Subject: VIRGIL C. SUMMER NUCLEAR STATION (VCSNS)
DOCKET NO. 50/395
OPERATING LICENSE NO. NPF-12
REQUEST FOR ADDITIONAL INFORMATION - GENERIC LETTER
95-07, "PRESSURE LOCKING AND THERMAL BINDING OF
SAFETY-RELATED POWER OPERATED GATE VALVES" OF JULY 3,
1996

**VCSNS RESPONSE TO THE REQUEST FOR ADDITIONAL
INFORMATION CONCERNING THE STATIONS INITIAL GENERIC
LETTER 95-07 "PRESSURE LOCKING AND THERMAL BINDING
OF SAFETY-RELATED POWER-OPERATED GATE VALVES"
SUBMITTAL.**

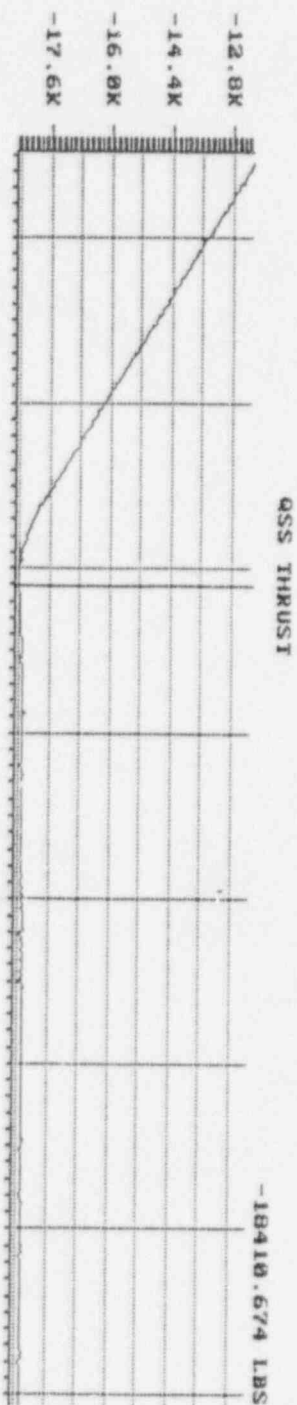
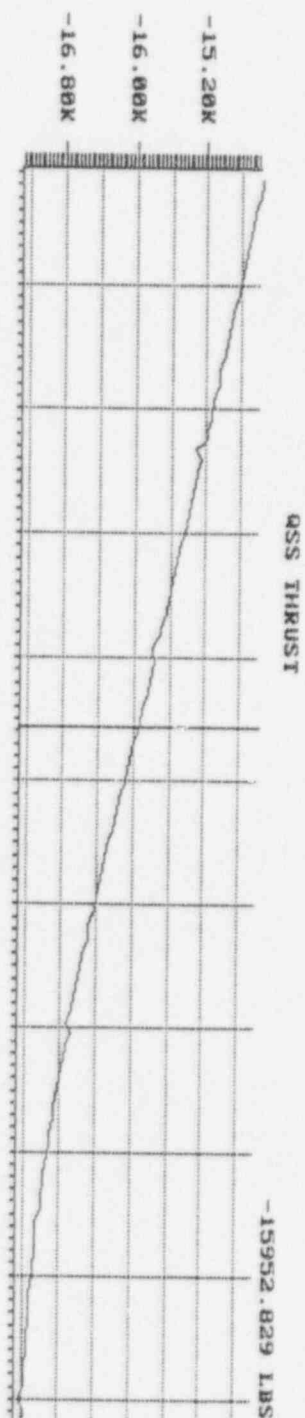
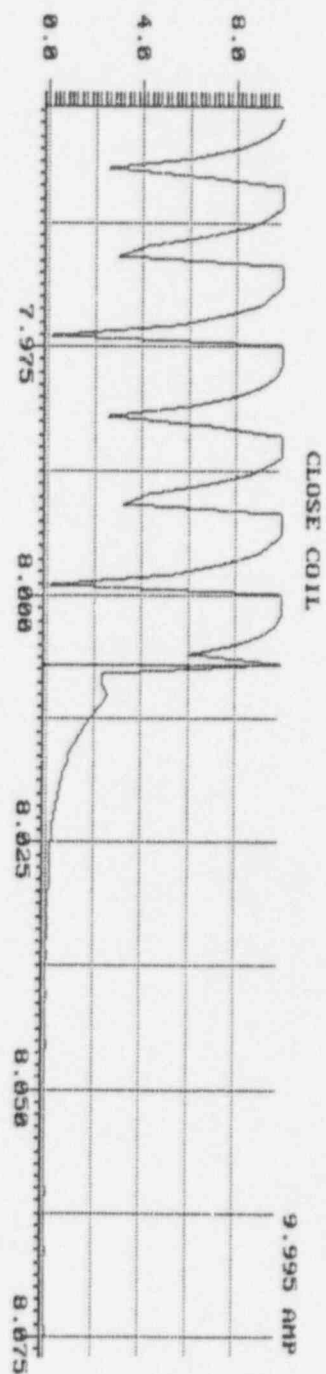
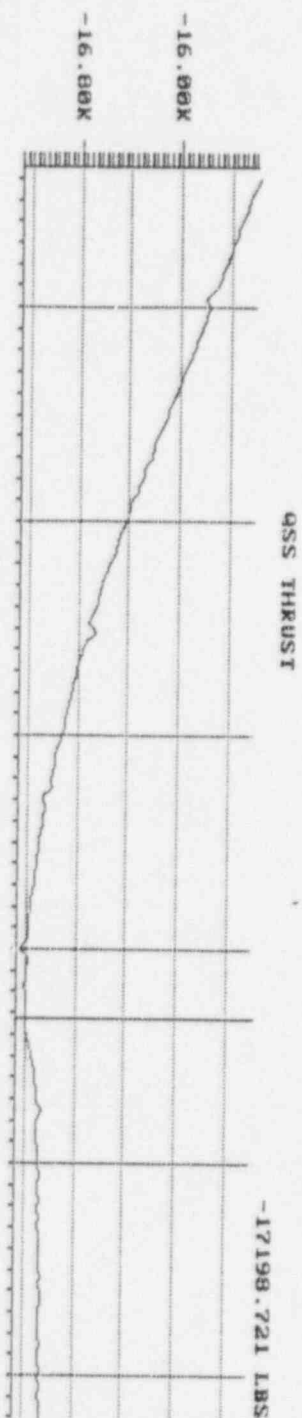
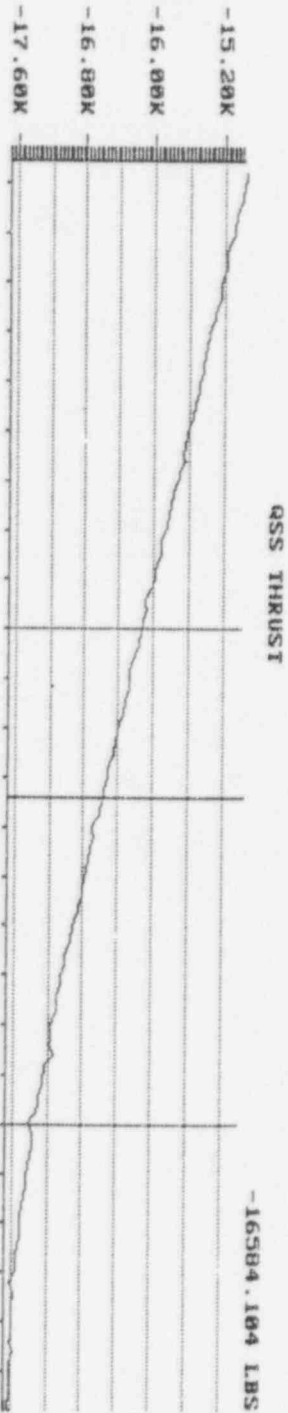
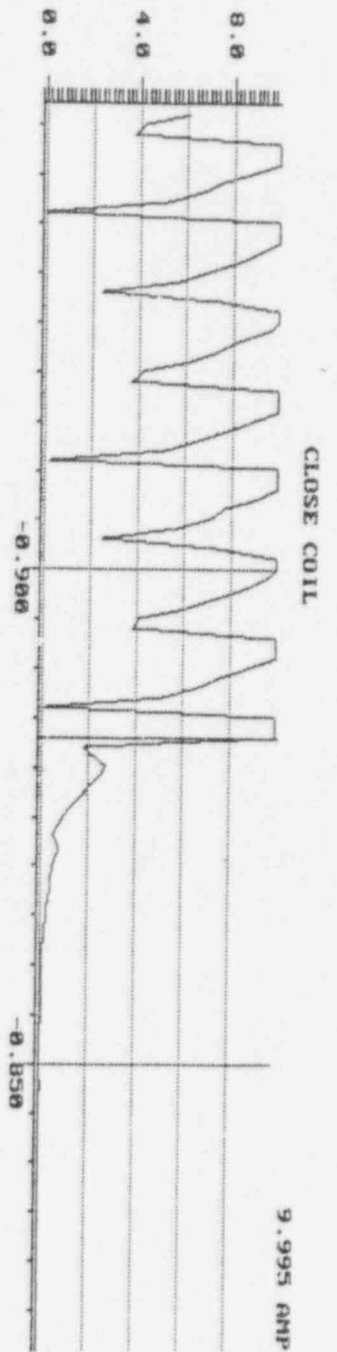
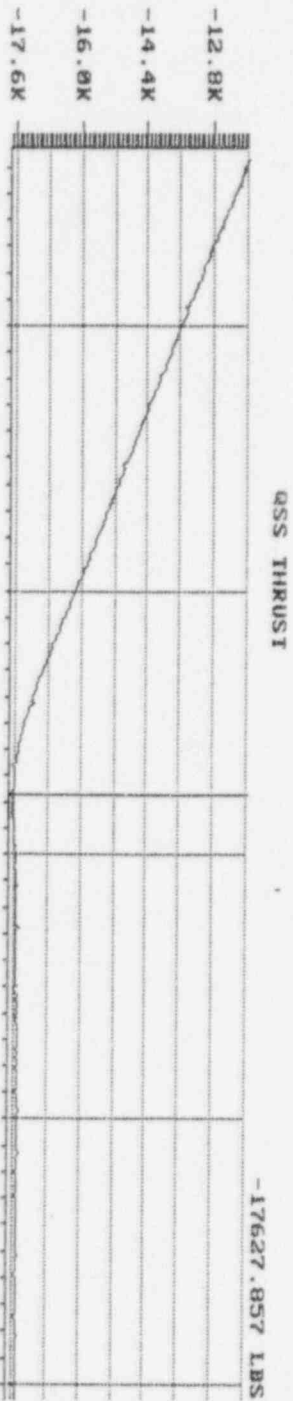
2. "The licensee's submittal discusses the susceptibility of valves 8000A/B/C, Pressurizer PORV Block Valves, to thermal binding. The licensee's submittal states that these valves have spring compensators which help mitigate the potential thermal binding condition. In addition, the licensee's submittal states that these valves have been closed numerous times during various modes of plant operation and subsequently reopened at ambient temperatures. Does the licensee have diagnostic test data that demonstrate that the spring compensators prevent excessive closing forces on the valve disk? Please discuss this issue and provide the results of the diagnostic tests, if applicable.

The licensee's submittal states that these valves are not used for cold over pressure protection. If these valves are shut to isolate a leaking PORV, would they remain shut as the plant cools down, and potentially have a requirement to open later for cold over pressure protection? Please address this scenario".

The Pressurizer PORV Block Valves (XVG08000A,B,C-RC) are fast acting valves that have Limitorque SB-00 actuators which are equipped with spring compensators. The spring compensator, which is a Belleville spring assembly mounted on top of the actuator, supports the stem nut instead of the stem nut being held rigidly in place by a lock nut as is the case for Limitorque actuators that are not equipped with spring compensators. The Belleville washers compress in response to the reactive upward force on the stem nut during the closing stroke which results in the Belleville washers

absorbing most of the additional thrust due to inertia. The Belleville washers will also absorb loads caused by thermal expansion, thereby keeping the valve disc from becoming too tightly wedged into the valve seat. In order for the Belleville washers to absorb the loads caused by thermal expansion the Belleville washers must not be in full compression as a result of the closing force. The static test as-left full stroke diagnostic traces for the PORV Block Valves indicate that the Belleville washers are not fully compressed during the closing stroke and the closing forces on the valve disk are not excessive (see attached traces).

The PORV Block Valves are not required to be opened for cold over pressure protection. Cold over pressure protection at VCSNS is provided by the RHR (Residual Heat Removal) suction relief valves. If one of the PORV Block Valves were shut to isolate a leaking PORV, and remained shut as the plant cooled down, the valve would not have a requirement to reopen.
